City of Richmond

Report to Committee Planning and Development Division

File: ZT 16-740866

Re: Application by Christopher Bozyk Architects Ltd. for a Zoning Text Amendment to the "Industrial Retail (IR1)" zone to Allow "Vehicle Sale/Rental" on up to 10% of the Gross Floor Area as an Additional Use at 4331 and 4431 Vanguard Road

SITE PLAN & MAIN FLOOR PLAN REZONING REVISIONS / PRELIMINARY ISSUE

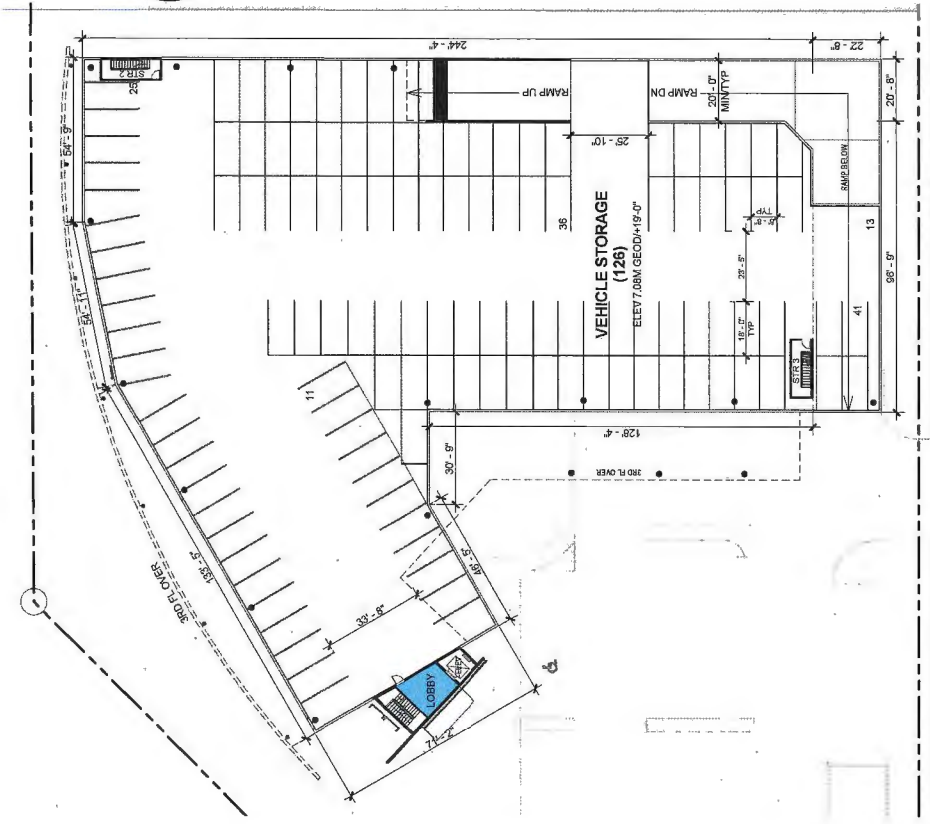
- Proposed height variances to accommodate the entrance tilt panel feature and the proposed building height.
- Reorganizing surface parking to eliminate overlapping handicapped parking spaces.
- Details for the vertical wall planting installation and plant selections.
- Review and refine the landscaping species selections and sizes as necessary. Addressing landscaping security requirements.
- Clarifying the location of a sediment separator and details of maintenance by the owner.
- Provision of bike parking spaces (indoor and outdoor) in compliance with the Zoning Bylaw.

- Modification of both driveway entrances to ensure a maximum throat width of 7.5 m and installation of a driveway letdown. Roll-over curbs may be accommodated outside the driveway letdown area for large vehicles.

- Relocate the proposed driveway off Vanguard Road (east/west portion) to as far west as possible.
- Size of parking stalls: confirm size of all stalls meets the Zoning Bylaw (ZB) requirements by showing on the plan the typical stall size. The following are the ZB requirements as the minimum stall dimensions:

- o Regular-size stall: Length (5.5 m) x width (2.65 m).
 - o Small-size stall: Length (5.0 m) x width (2.4 m).
 - o Handicapped stall: Length (5.5 m) x width (3.7 m).

- Ensure both Class 1 and 2 on-site bicycle parking spaces are provided as per bylaw requirements. Applicant to address and show these on the plans.
- Reorganize the surface parking to eliminate overlapping handicapped parking spaces. Each handicapped space must be a minimum of 3.7 m wide.

SECTION & ELEVATIONS DESIGN & REZONING REVISIONS

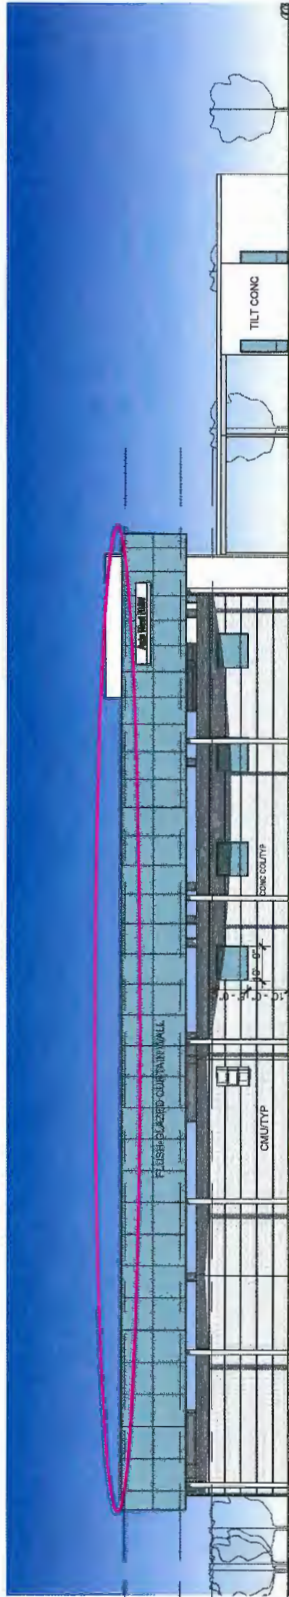
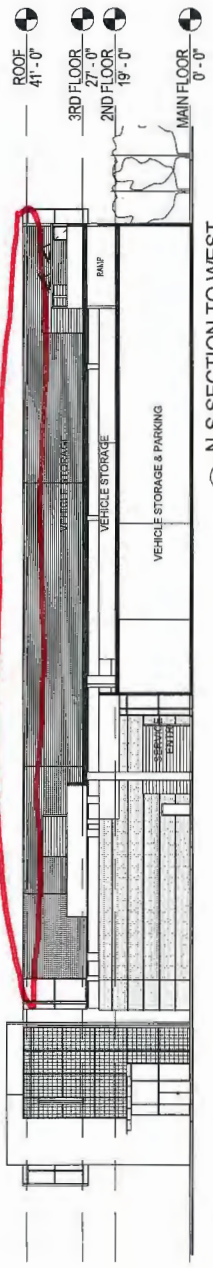
The conceptual development plans (Attachment 3) indicate that there are three areas of the proposed building which will exceed the 12 m maximum height established by the site's "Industrial Retail (IR1)" zoning. These include:

- A tilt up entrance panel is proposed as both an architectural feature/highlight and a functional feature intended to clearly identify the main entrance of the building and is proposed to be 14.02 m (46 ft.) tall.

- The show room roof is proposed to be 12.5 m (41.0 ft.) tall which is needed to accommodate, in particular, clearances for the two floors below
- The proposed roof parapet at 12.62 m (41.42 ft.) to screen parking from surrounding properties.

Details for the requested variances will be addressed in more detail through the Development Permit review.
